DEVIATION REQUEST AND DECISION FORM

Project Name : Sterling Ranch - CDR 20-005 Vollmer, Marksheffel and Sterling Ranch Rd. Construction Drawing Review
 Schedule No.(s) : 5200000364
 Legal Description : PT SE4SE4 LY S of Vollmer Rd ex RD w/ MR Sect 32-12-65 Ex Tr 2 Conv by Rec #210065613

A deviation from the standards of or in Section **ECM section 2.2.4 Roadway Functional Classifications** of the Engineering Criteria Manual (ECM) is requested for the Marksheffel Road Right of Way and cross section.

TYPICAL SECTION
MARKSHEFFEL ROAD
STERLING RANCH FIL 2
JOB NO. 2518801
JAN, 26, 2021
SHEET 1 OF 1

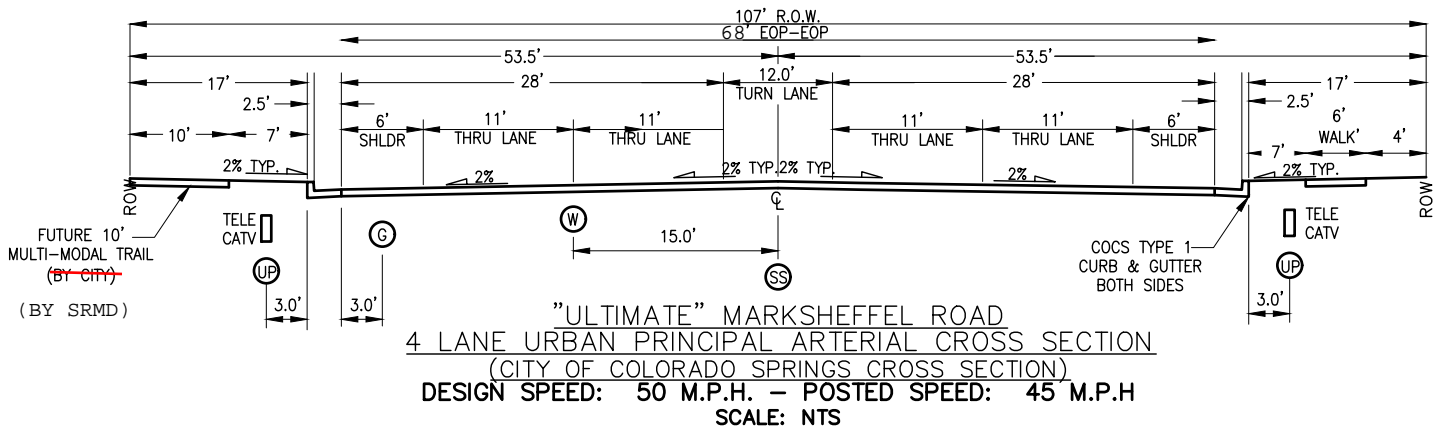
- Conditions of deviation approval:
1. El Paso County will not maintain Marksheffel road with the proposed design, and will only facilitate approvals and coordinate transfer of the road, upon completion of construction, to the City of Colorado Springs. Ultimate plan approval, notice to proceed and MS4/stormwater enforcement remains under the County’s jurisdiction until such time that the road is actually annexed into the City.

2. Construction of the approved cross-section (above) is at the developer’s risk as the County cannot guarantee City acceptance of the road and associated deeds. Any revisions necessary to meet County requirements due to a change in City commitments will be the developer’s responsibility.

3. The City may require construction of the full four-lane cross-section from Vollmer Road southeast along Platted area (Sterling Ranch Filing No. 2).

4. The City may require a 25% escrow contribution to the traffic signal at Vollmer Road.
 5. Tahiti Drive will be closed at the Marksheffel /Vollmer intersection.

6. Any additional easements necessary for drainage, slope easements and other public improvements shall be shown on plans as “public improvement easements”. If these easements are required, they shall be provided by separate recorded document (non-exclusive public easements) approved by El Paso County and referenced on the plans prior to plan approval.

7. A 25-foot non-exclusive County trail corridor easement is required along the northeast side of Marksheffel Road and shall be shown on all plans. It is assumed that this corridor will remain under County jurisdiction.

MARKSHEFFEL ROAD (107' ROW)
(MODIFIED) 4 LANE URBAN MINOR ARTERIAL CROSS SECTION
SCALE: NTS

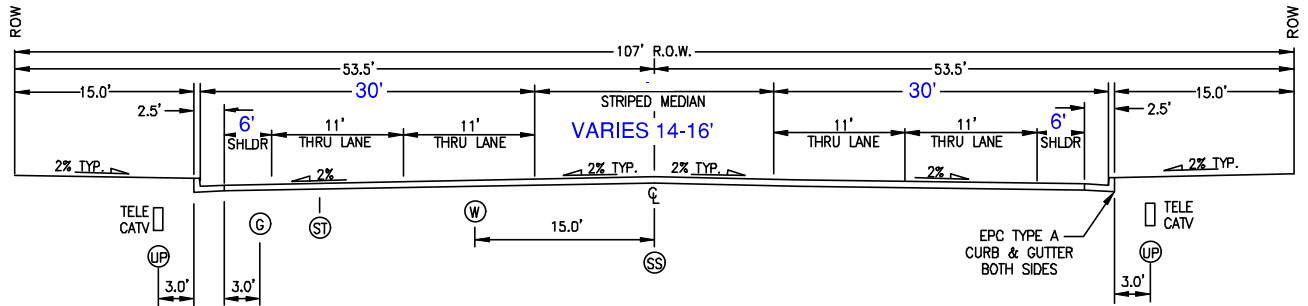
Cross section above is as agreed to by Kathleen Krager and Jeff Rice on November 29, 2018.

Conditions of deviation approval:

1. El Paso County will not maintain Marksheffel Road with the proposed design, and will only facilitate approvals and coordinate transfer of the road, upon completion of construction, to the City of Colorado Springs. Ultimate plan approval, notice to proceed, and MS4/stormwater enforcement remains under the County's jurisdiction until such time that the road is actually annexed into the City.

2. Construction of the approved cross-section (above) is at the developer's risk as the County cannot guarantee City acceptance of the road and associated deeds. Any revisions necessary to meet County requirements due to a change in City commitments will be the developer's responsibility.

3. The City may require construction of the full four-lane cross-section from Vollmer Road southeast along platted areas (Sterling Ranch Filing No. 2).

4. The City may require a 25% escrow contribution to the traffic signal at Vollmer Road.
5. The intersection at Vollmer Road shall be designed and constructed to allow for realignment of Tahiti Drive from the northwest at an appropriate location entering the new intersection.

6. Any additional easements necessary for drainage, slope easements and other public improvements shall be shown on plans as "public improvements easements." If these easements are required, they shall be provided by separate recorded document (non-exclusive public easements) approved by El Paso County and referenced on the plans prior to plan approval.

7. A 25-foot non-exclusive County trail corridor easement is required along the northeast side of Marksheffel Road and shall be shown on all plans. It is assumed that this corridor will remain under County Jurisdiction.
